PLATTING BOARD AGENDA

PLATTING BOARD MEETING

November 17, 2022

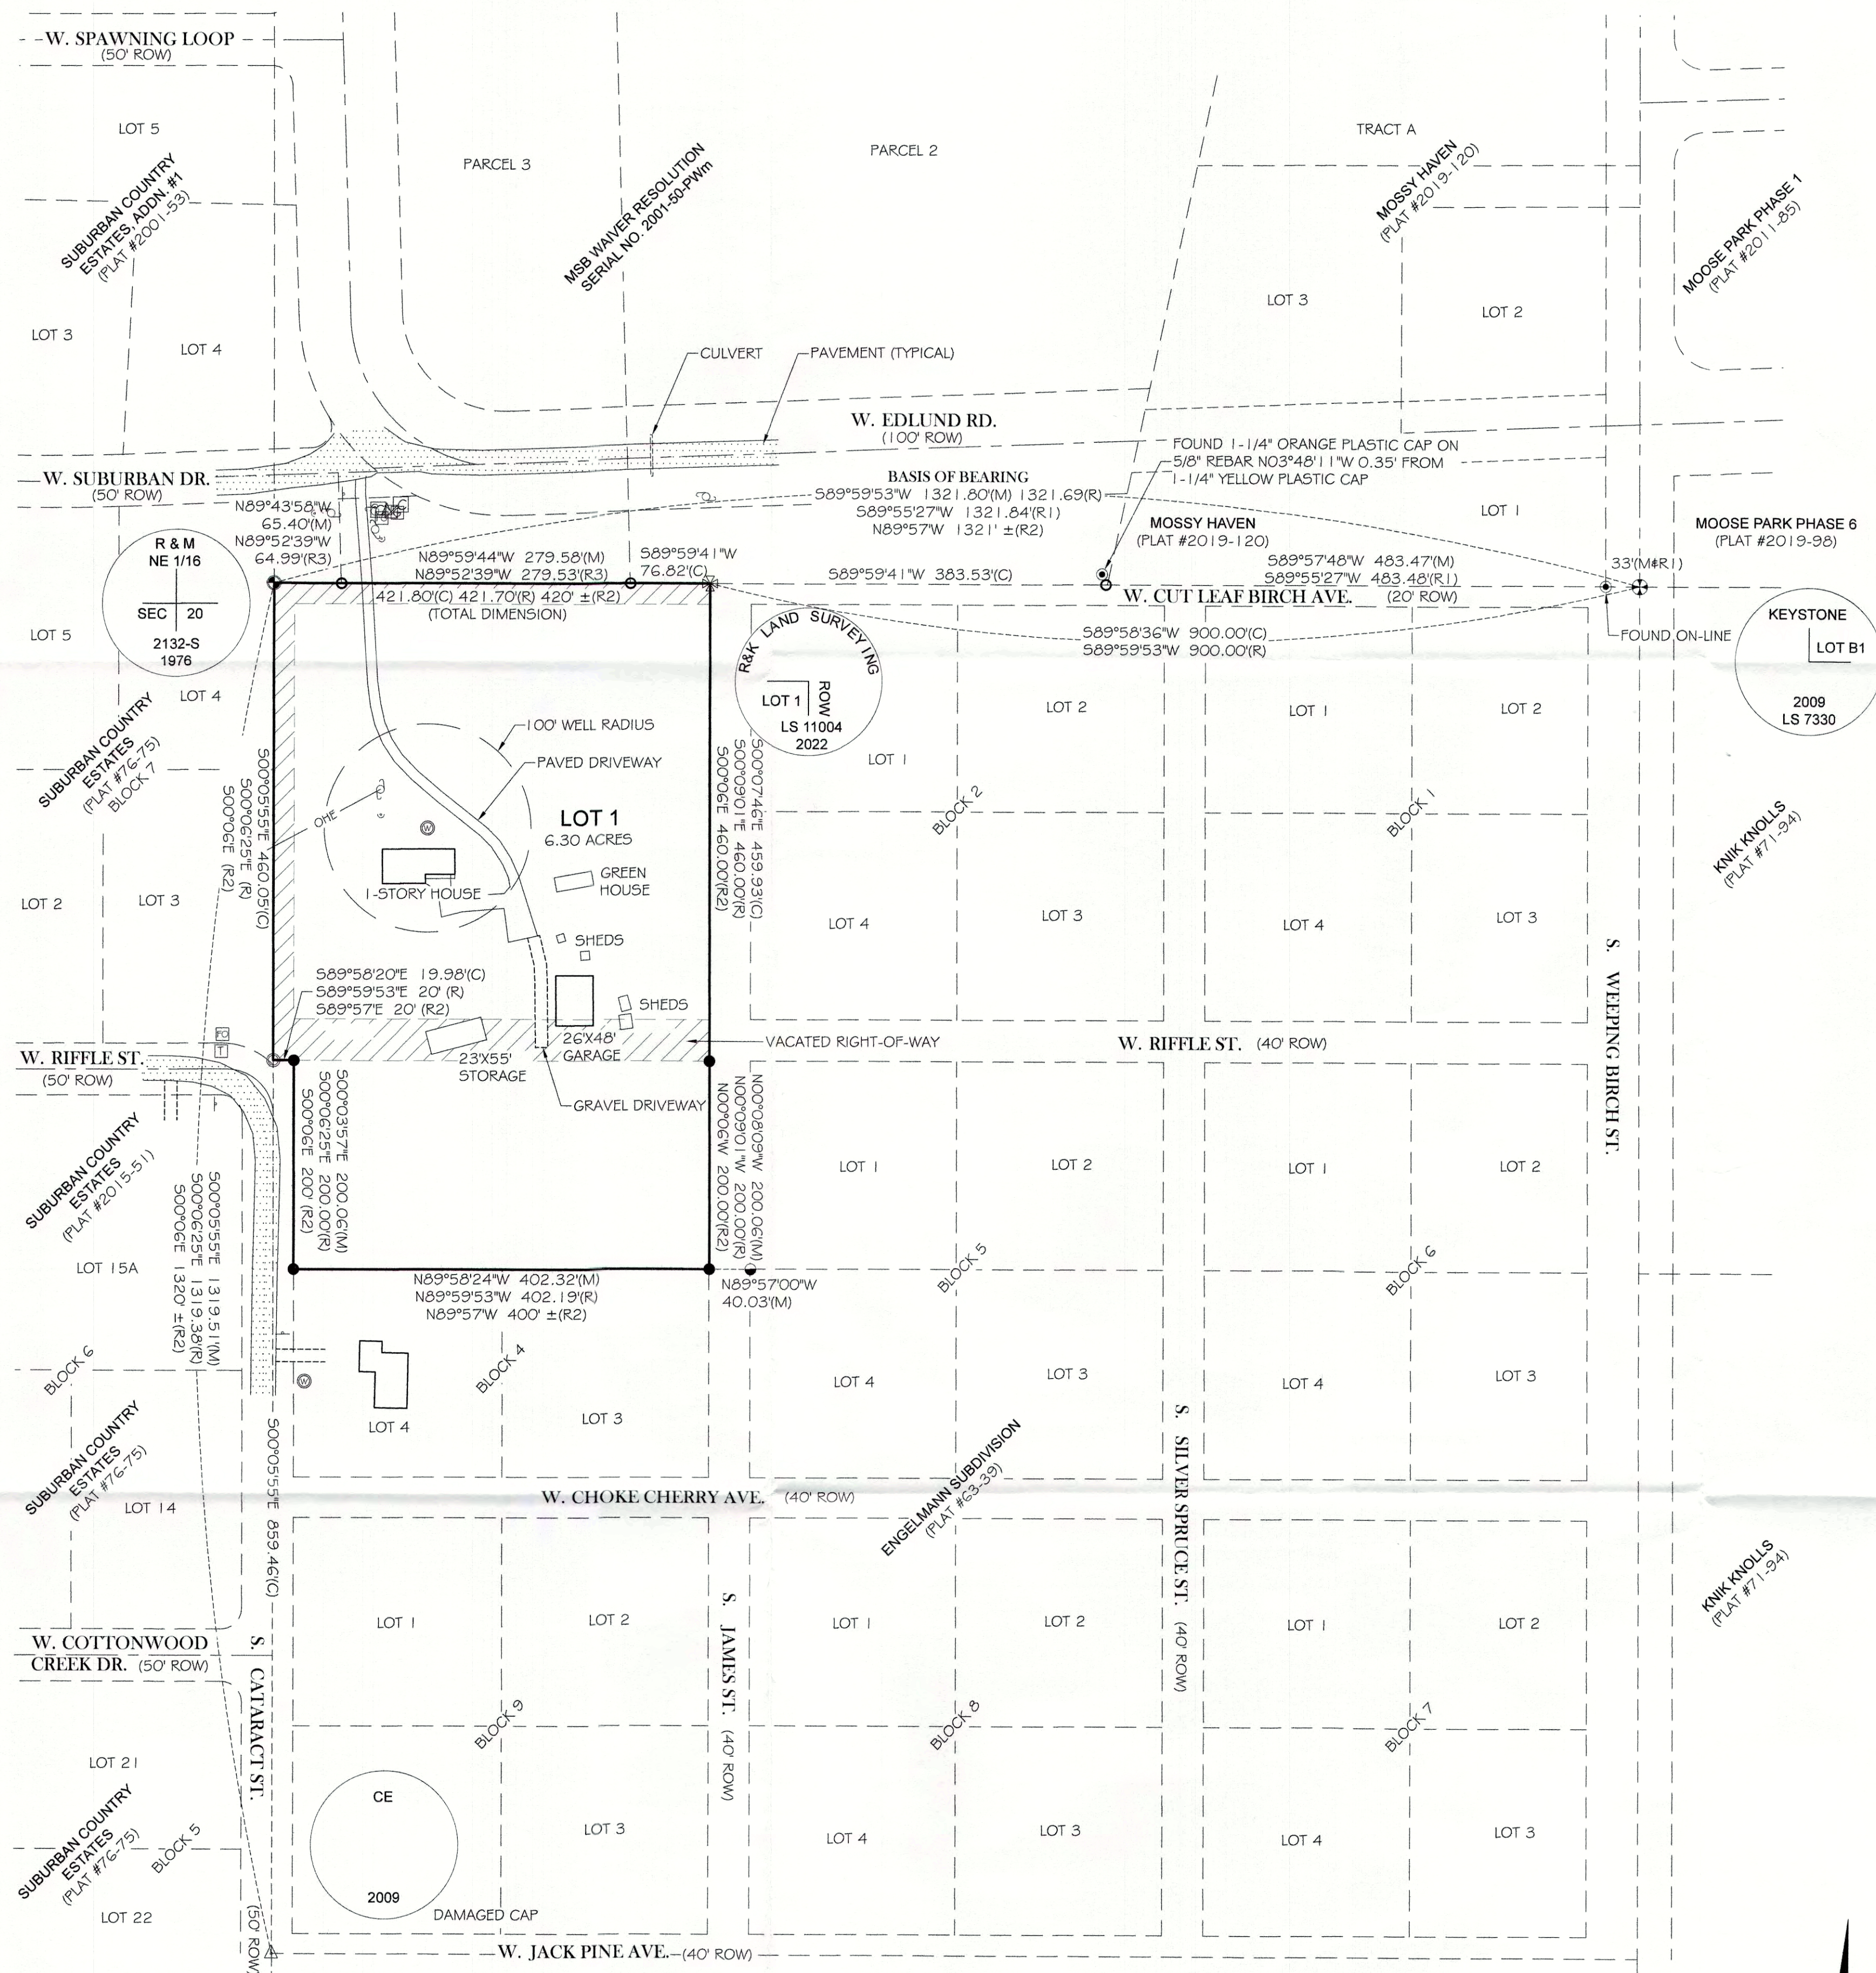
1. Add a note which says, "There is a fifteen foot (15 FT) wide natural gas easement centered on the existing main and service line." And draw in the approximate location of the natural gas main and service line on the map and add, "Approximate location of natural gas main and service line and centerline of fifteen foot (15 FT) wide natural gas easement".
2. Owner signs an ENSTAR Natural Gas Easement document for a fifteen foot (15 FT) wide natural gas easement, centered on the service line at this location.

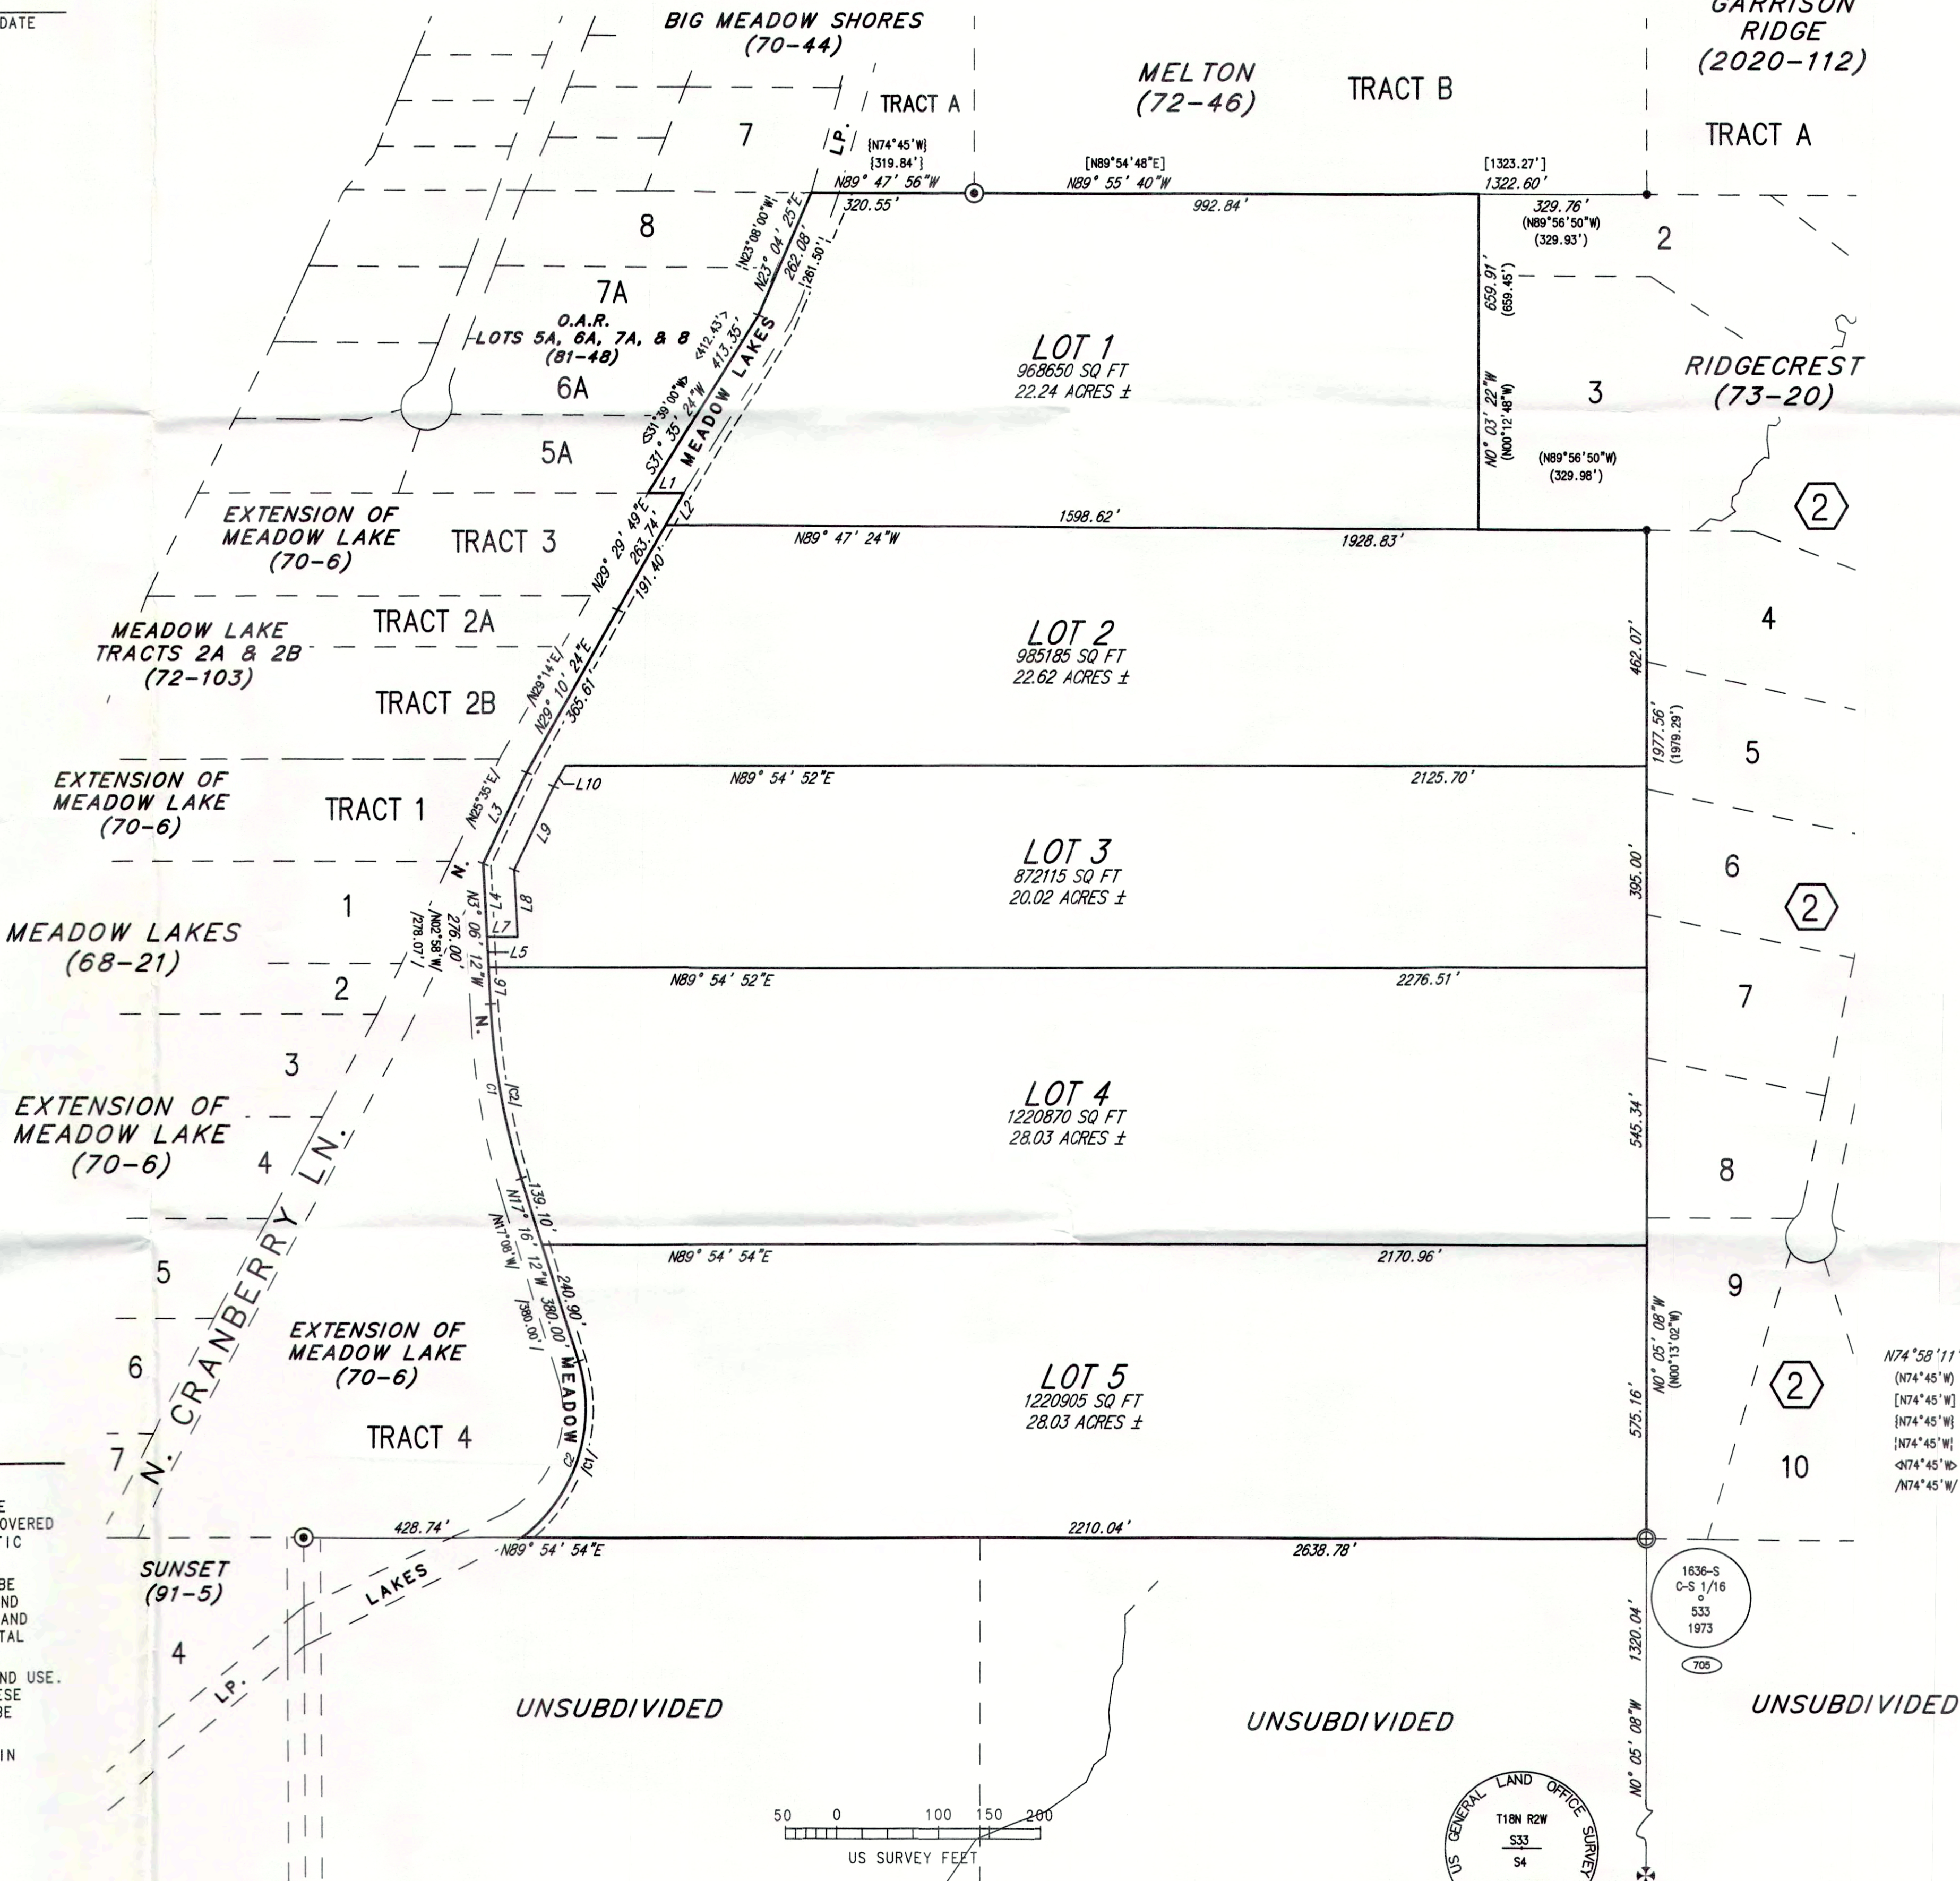
In review GCI has no objections only the following comment for the attached signed plat.

The legal description in the title block needs to show the Range to be 2W.
